Product Change Notification

PANEL CONTROLS

Model PC Termination Ink Upgrade

Element Collector Ring

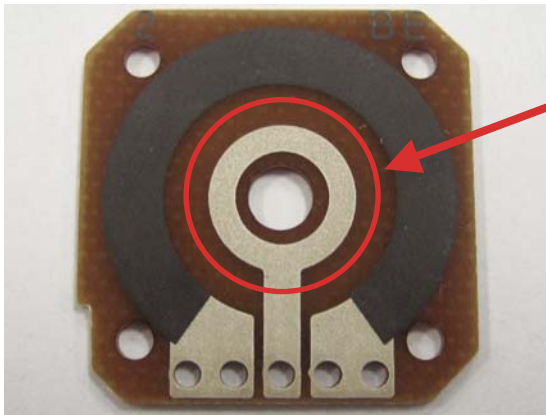
The current termination ink used in printing the collector ring is CPC-30. This ink will be changed to Minico 4100, which has improved wear characteristics. Please refer to the photo showing the area where the collector ring is printed on the element.

This termination ink upgrade does not affect fit, form or function of the product. Production transition to the new termination ink started the week of September 18, 2007, with date code 0738M. Qualification test data is available upon request. There will be no changes to MOQ/Mults or price on this product upgrade.
